QSE REFERENCE DESIGN ERRATA

5 GBIT/S ATM SWITCH FABRIC ELEMENT (QSE)

REFERENCE DESIGN ERRATA

ISSUE 1: AUGUST 1999

Figure 1 - Coupling for HDMP-1034 Devices

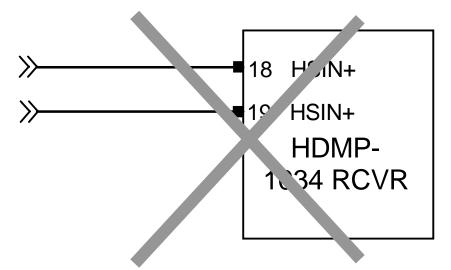
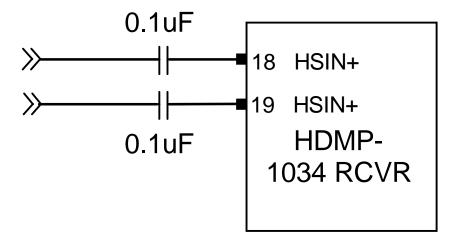
On Pages 9 and 10 of the QSE Reference Design schematics, pins 18 and 19 of devices U7 - U14 are shown directly coupled to signals R0_GRP0+/- through R0_GRP7+/- respectively. These signals should instead be AC coupled to pins 18 and 19. The same case applies on Pages18 and 19 for devices U25 – U32. Figure 1 below illustrates the error and the correct connections.

The corrected schematic diagram corresponds to termination recommendations provided in HP datasheets.
